Technical Service Bulletin

NOISE FROM REAR BRAKES DUE TO BRAKE DRAGGING

Bulletin No.: 04-001/18

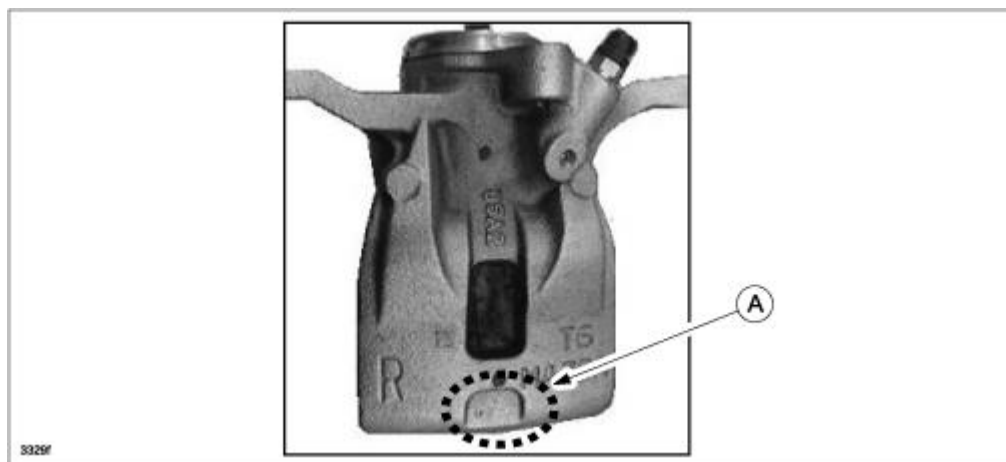
NOTE: Part numbers of caliper have not been changed by this modification. Distinguish the modified one from old one using the 3-digit lot number (Production Date) stamped on the caliper (A).

Calipers with the lot number (production date) of **697 (2016/09/07)** and higher are modified.
